RE: **Lot 14 Block 9 Unit 22 SAD 228
6415 Petirrojo NW
Volcano Cliffs Subdivision
Grading and Drainage Plan
Engineers Stamp Date 6/3/2020 (D10D003Q14)**

DRAINAGE AND TRANSPORTATION INFORMATION SHEET (REV 6/2018)

ENGINEER'S SEAL	LOT 14 BK 9 U 22 VOLCANO CLIFFS SUB. 6415 PETIRROJO ROAD GRADING AND DRAINAGE PLAN	DRAWN BY DEM
		DATE 6-2-19
6/3/20		SHEET # C1
DAVID SOULE P.E. #14522	1606 CENTRAL AVENUE SE SUITE 201 ALBUQUERQUE, NM 87106 (505) 972-0899	JOB #

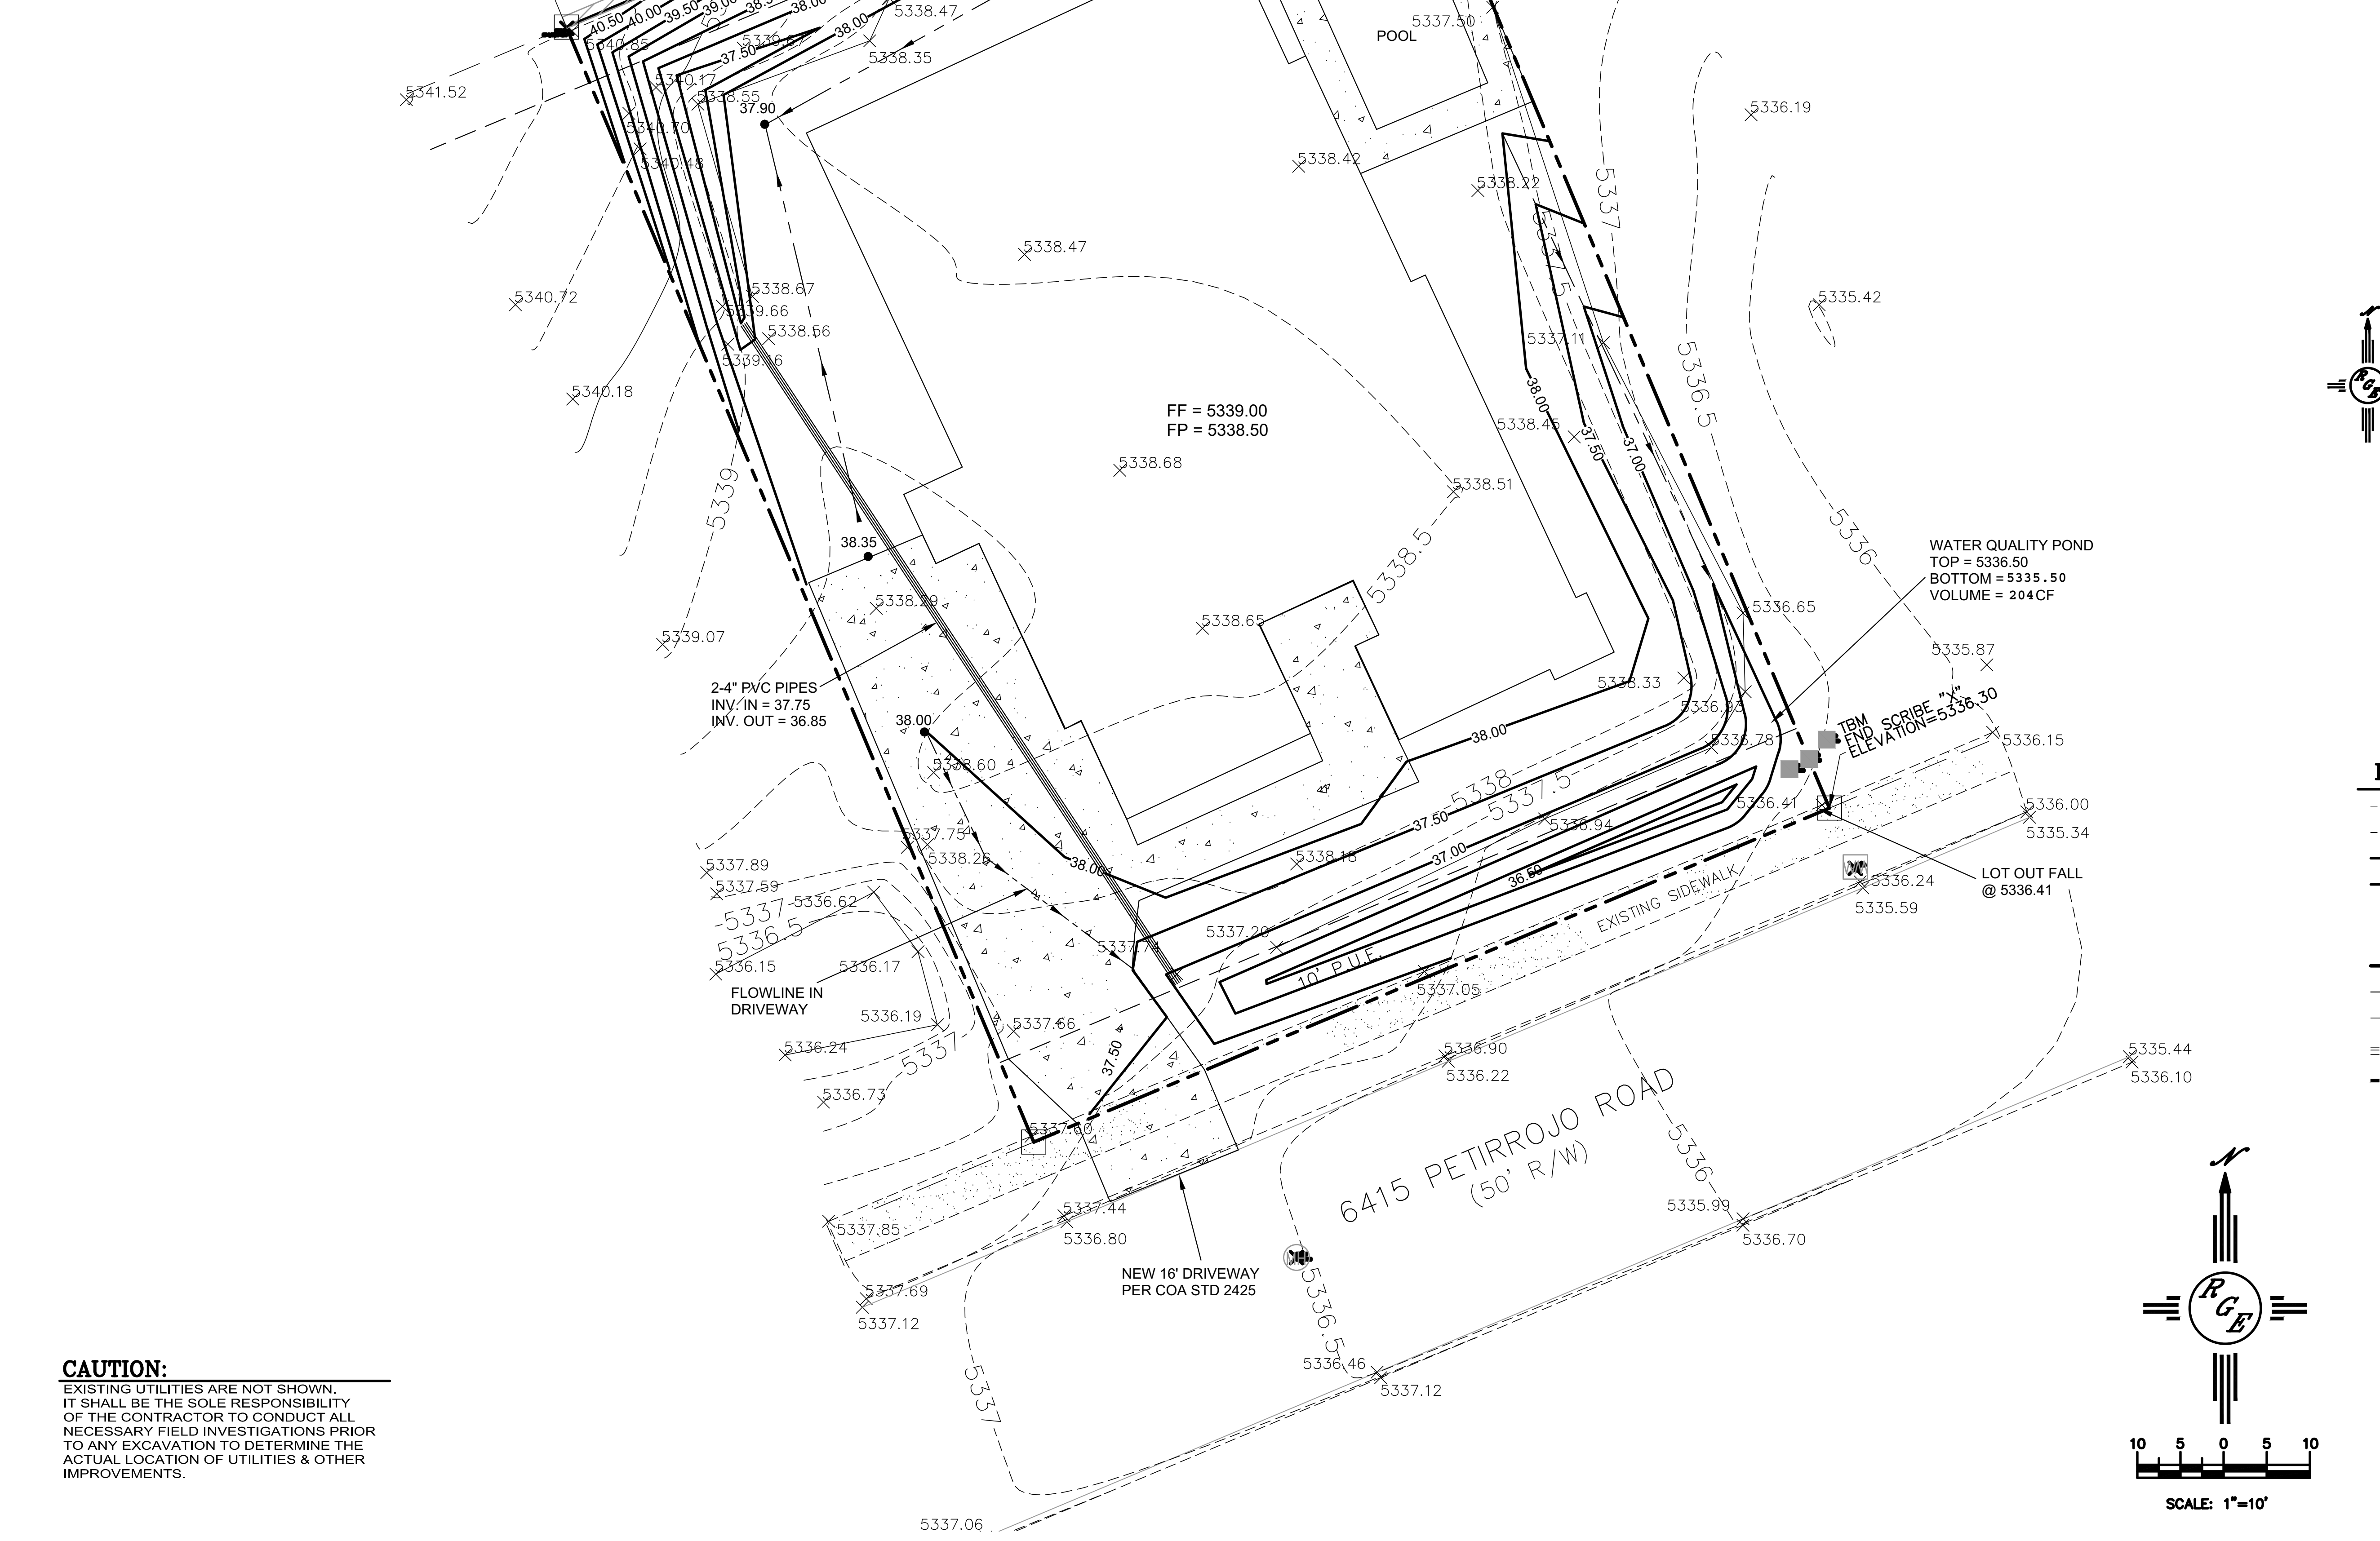
Prior to Building permit approval a Pad Certification will be required, provided by the Engineer or a registered Land Surveyor.

Advise the owner contractor not to use dirt as a ramp to climb the curb, use lumber or crusher fines for this purpose.

Reiterate to the Owner/Contractor that a separate permit for a garden/retaining wall must be obtained with the approved G&D plan and Pad Certification. Also, if a swimming pool is to be placed the grading and drainage plan will change and will need to be resubmitted.

Prior to Certificate of Occupancy release, Engineer Certification per the DPM checklist is required.
